IEEE P802.11  
Wireless Access Method and Physical Layer Specifications

**Title: Tx power Control provisions in the MAC.**

This document intend to describe what the draft text changes are for the support of a Tx power Control provisions in the MAC.

**Figure 4-xx: CTS Frame**

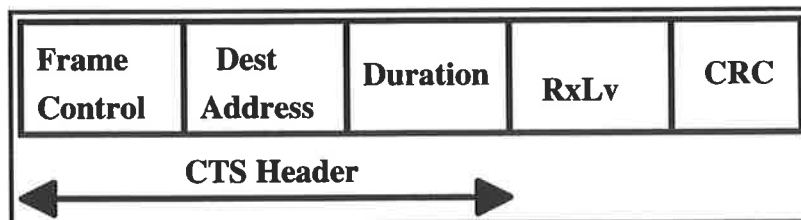
Specify a new field in the CTS frame described in section 4.2.1.2, and an identical change in section 4.2.1.3 to describe the Ack frame.

The Destination address of the CTS frame shall be taken from the source address of the RTS frame to which the CTS is a response.

The RxLv field shall contain the RSSI indication by the Phy of the RTS frame.

Figure 4-xx: ACK Frame

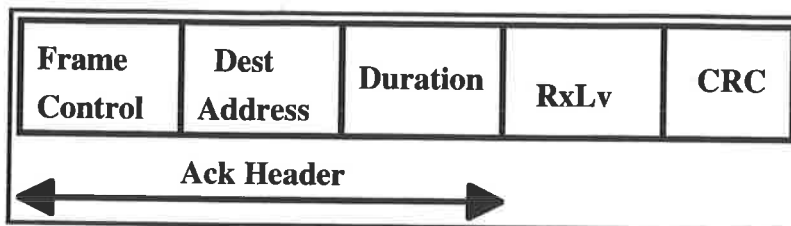
The Destination address of the Ack frame shall be the source address field of the immediate previous data or management frame, if the station is an AP. The destination address shall be the BSS Identifier of the immediate previous data or management frame, if the station is not an AP.

The RxLv field shall contain the RSSI indication by the Phy of the previous data or management frame.
